Modifications to the Recirculated Draft EIS/EIR

This section of the document addresses modifications to the April 2008 Recirculated Draft EIS/EIR for the Berths 97-109 Container Terminal project (proposed Project) at the Port of Los Angeles (Port). It presents all revisions related to public comments, as determined necessary by the lead agencies, for the Executive Summary, Introduction, Project Description, and Environmental Analyses. Any revisions to supporting documentation such as the references, list of preparers, acronyms and abbreviations, and appendices are also presented. The numbering format from the Recirculated Draft EIS/EIR is maintained in the sections presented here, although only sections that had revisions based on the public comments are included; sections that had no revisions are not included. Readers are referred to the April 2008 Recirculated Draft EIS/EIR to view complete sections.

Figure ES-2 Proposed Project at Buildout

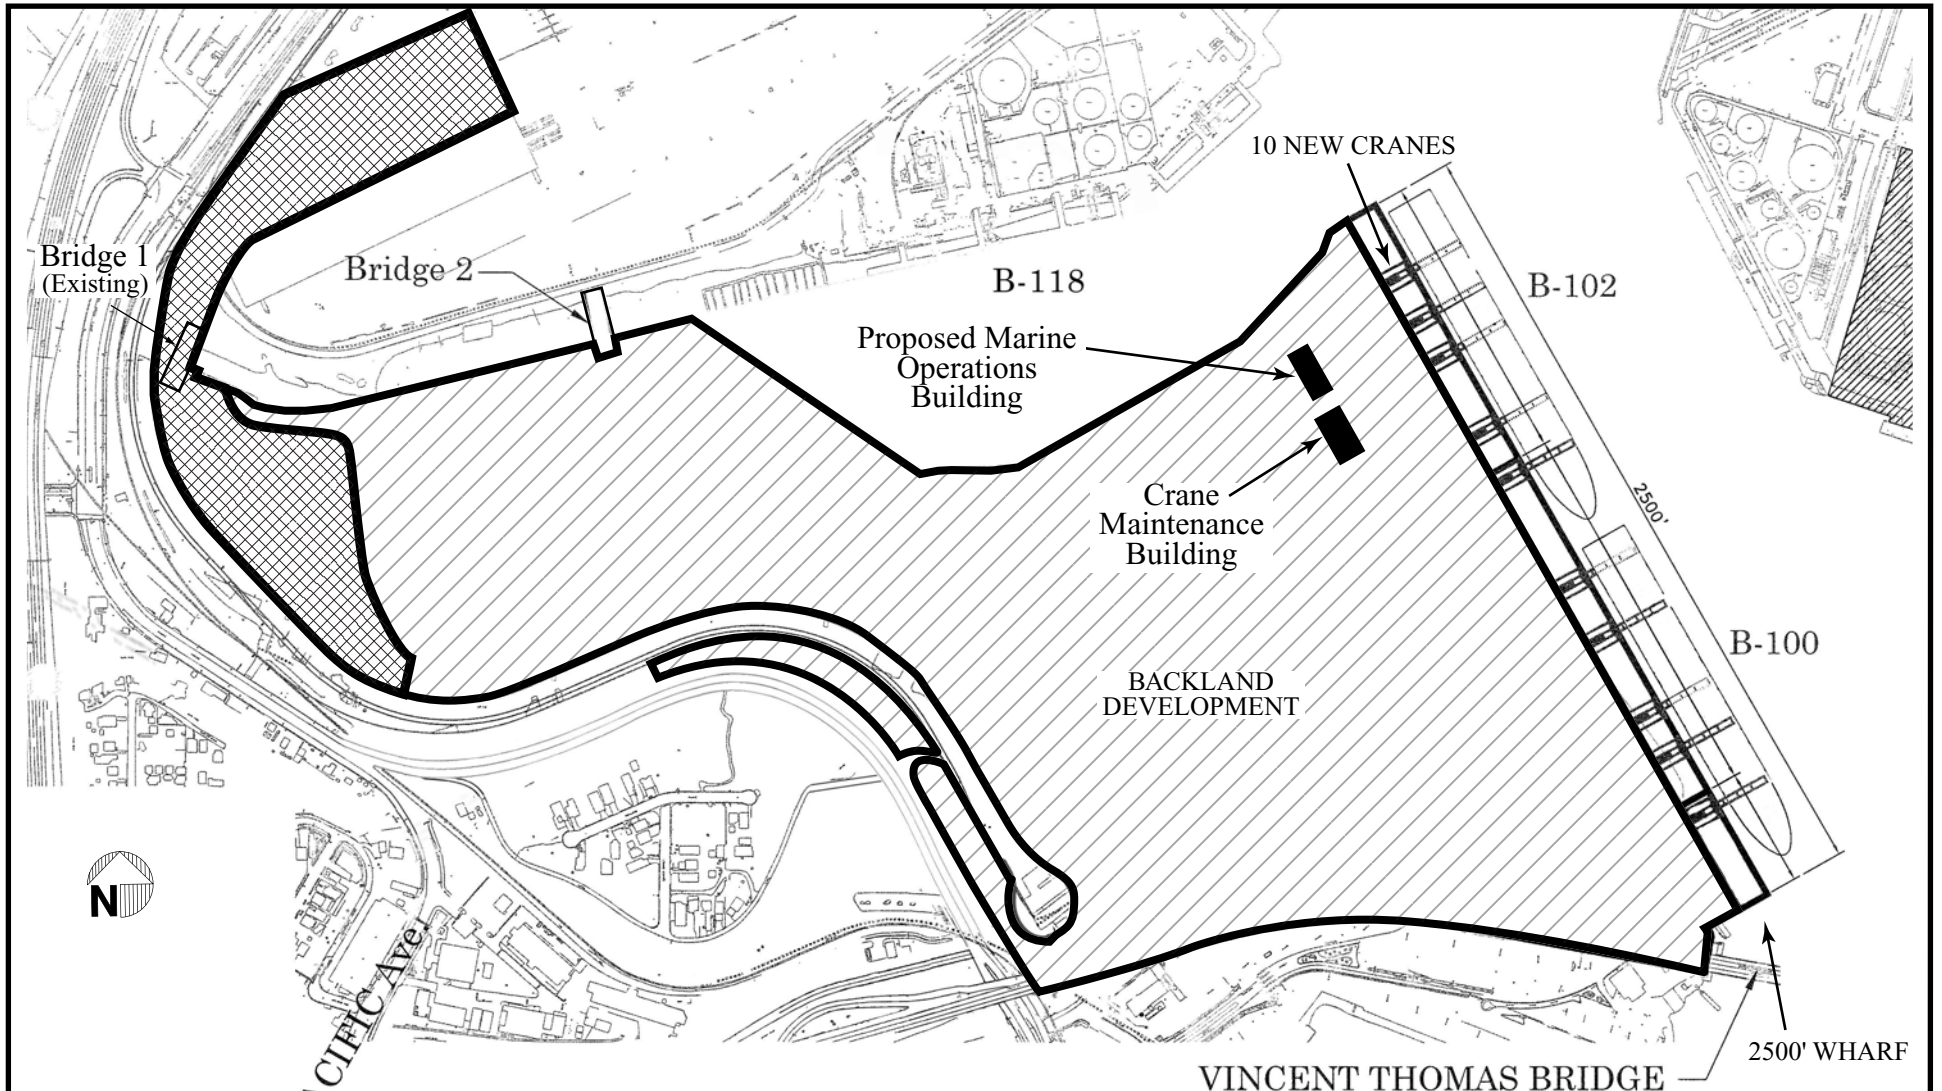
Figure ES-2 has been revised to reflect a more current location of the Marine Operations Building and the Crane Maintenance Building.

44 **Figure 2-6 Federal Action**

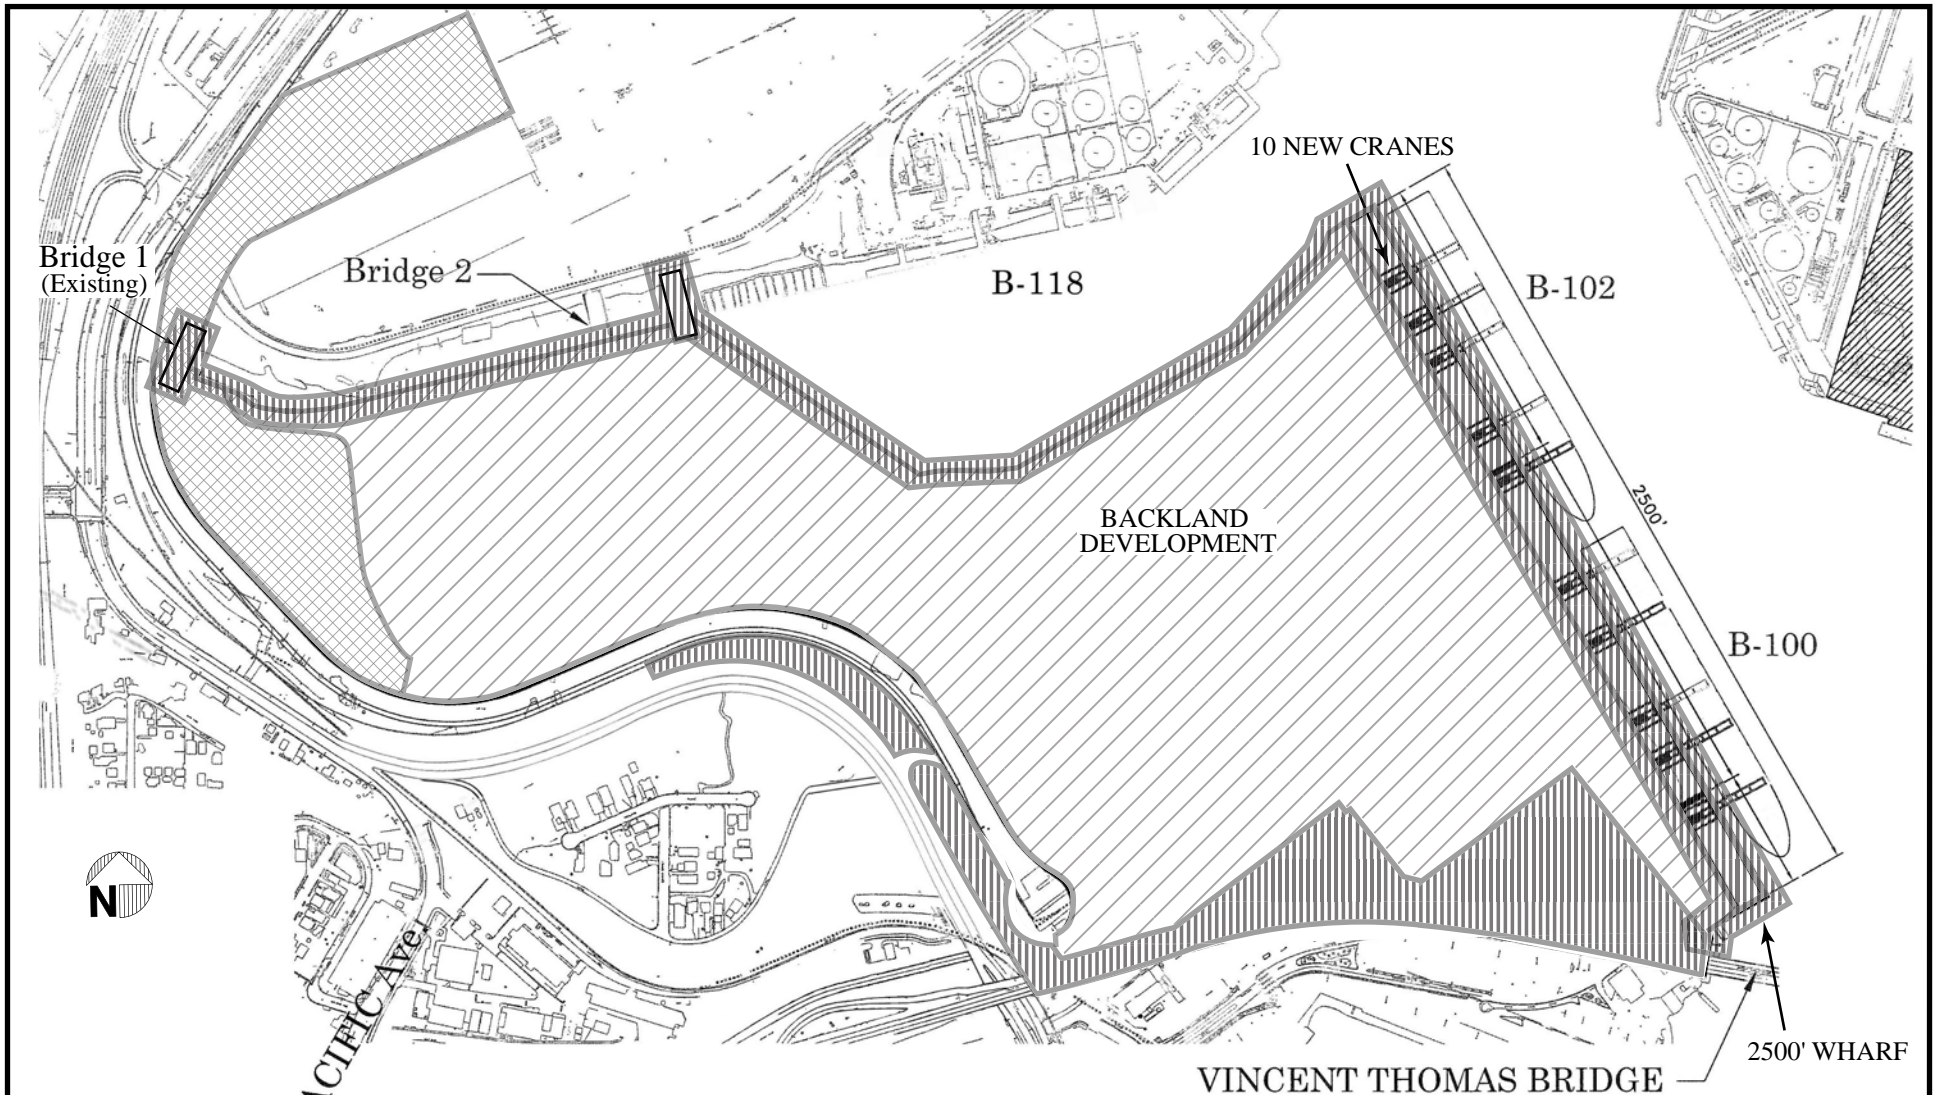
45 Figure 2-6-2 has been revised to clarify the federal ~~project~~ action and the extent of NEPA
46 analysis in the EIS.
